PUBLIC INTEREST REVIEW FOR GROUNDWATER APPLICATIONS

SUBJECT: Application G- 17990 Supersedes review of _____
Date of Review(s)

A. GENERAL INFORMATION: Applicant's Name: Philip Hammak County: Lake

Groundwater Permit Application G-17990 Hamak Corporation.

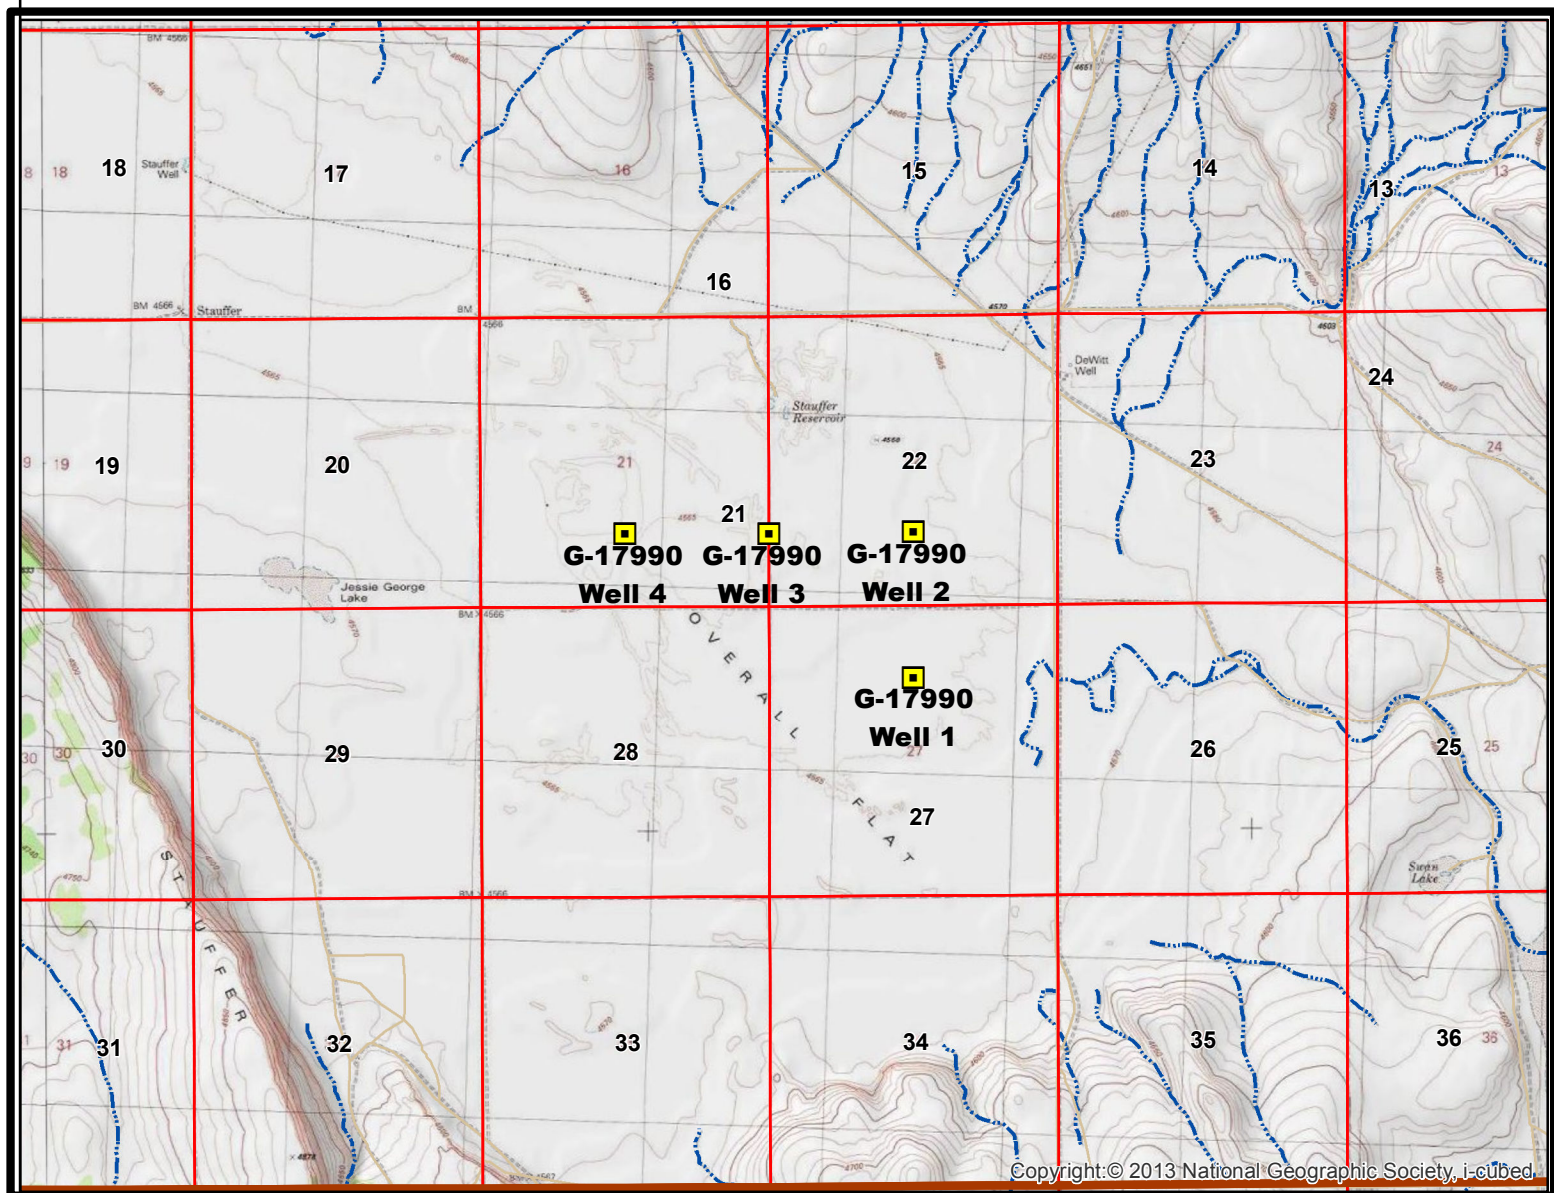
Well Location Map: see attached
